Re: Additional Information regarding MW-1 water levels

Brannan Sand and Gravel has investigated the items detailed in your letter dated January 31, 2022. Please see our responses to DRMS's concerns below.

FIGURE C-4
BRANNAN SAND & GRAVEL
JOB NO. 14457.01
JULY 2003
MINING PLAN
JAN 14 2004

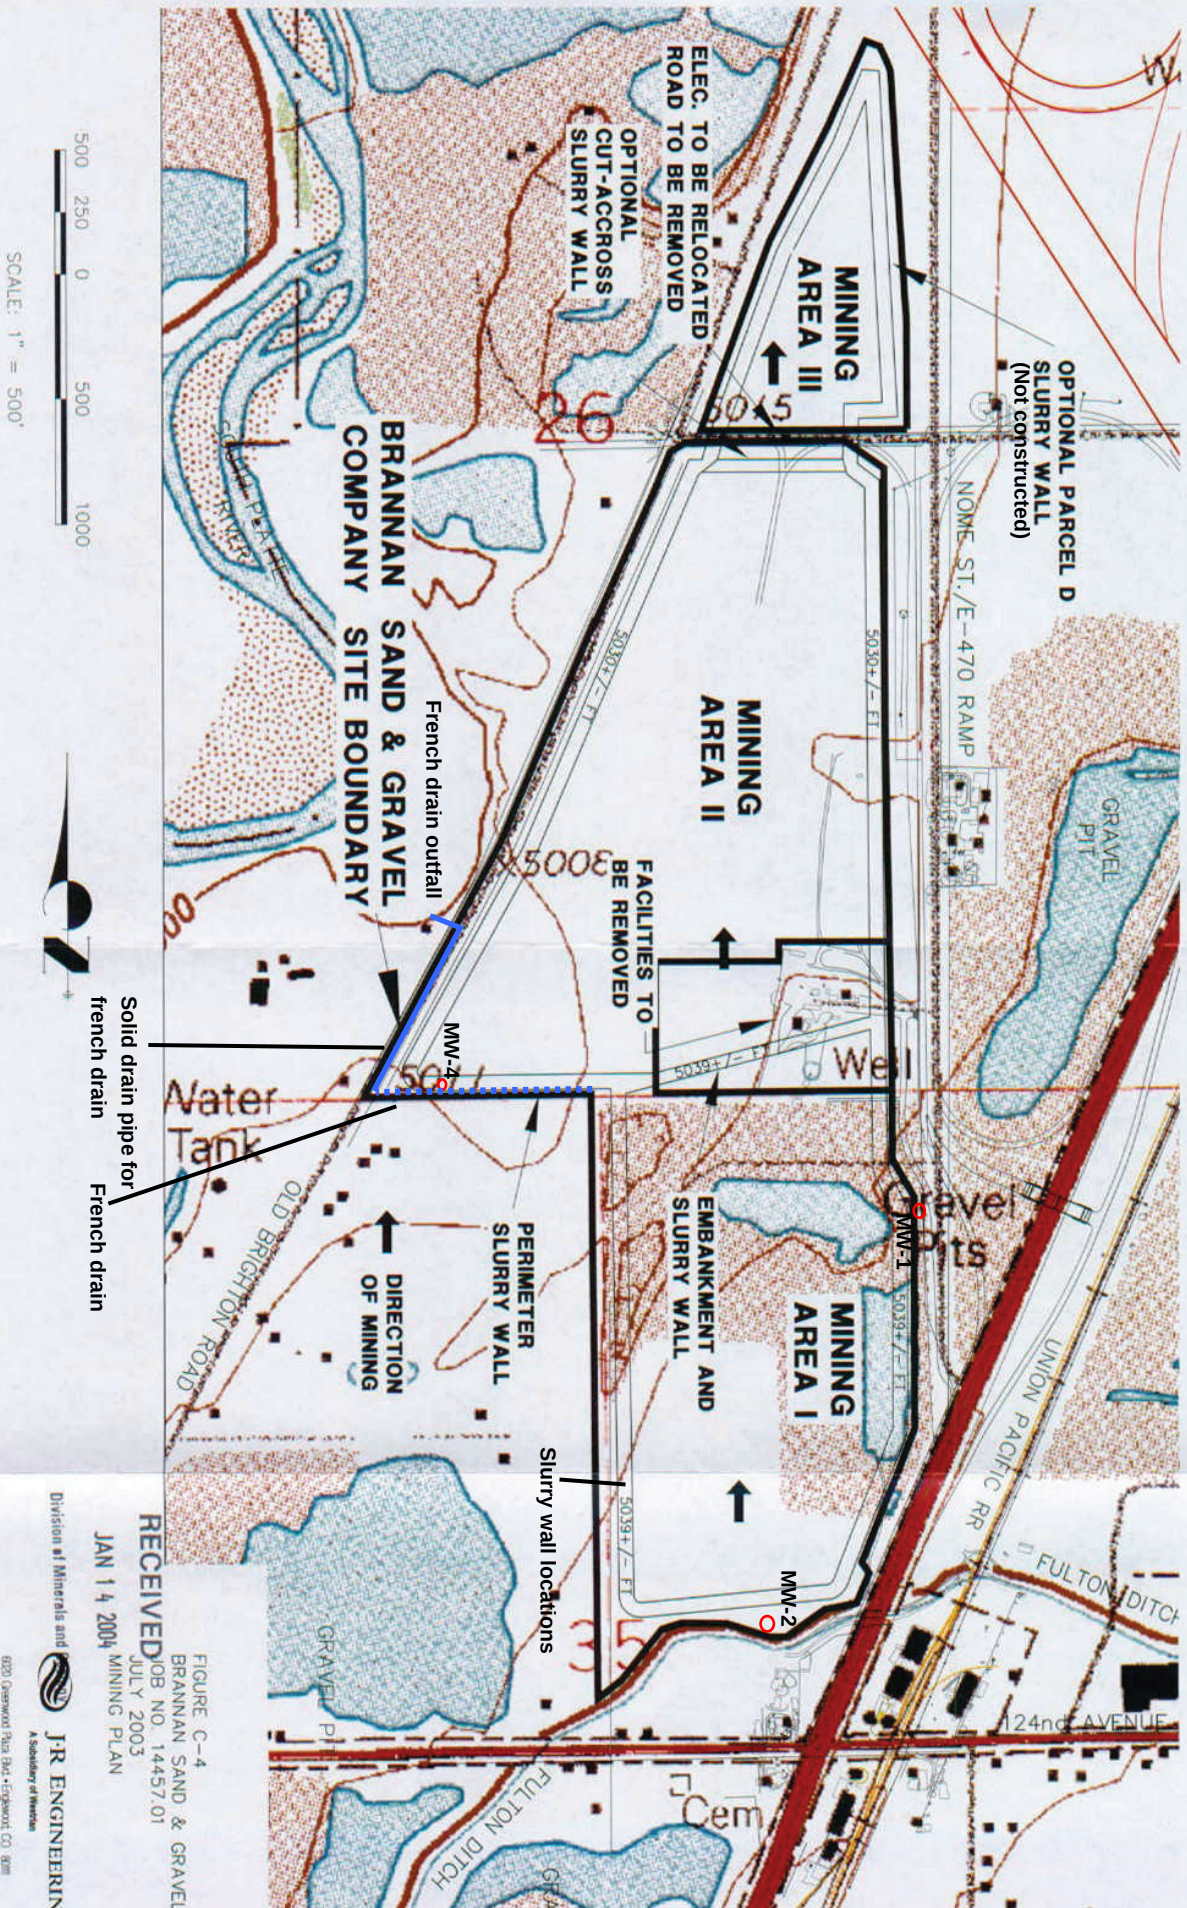
1. Please submit an updated map depicting the slurry wall locations, monitoring well locations, the location of the french drain and the permit boundary.

Please see the attached map showing the slurry wall locations, monitoring well locations and the location of the French drain and permit boundary.
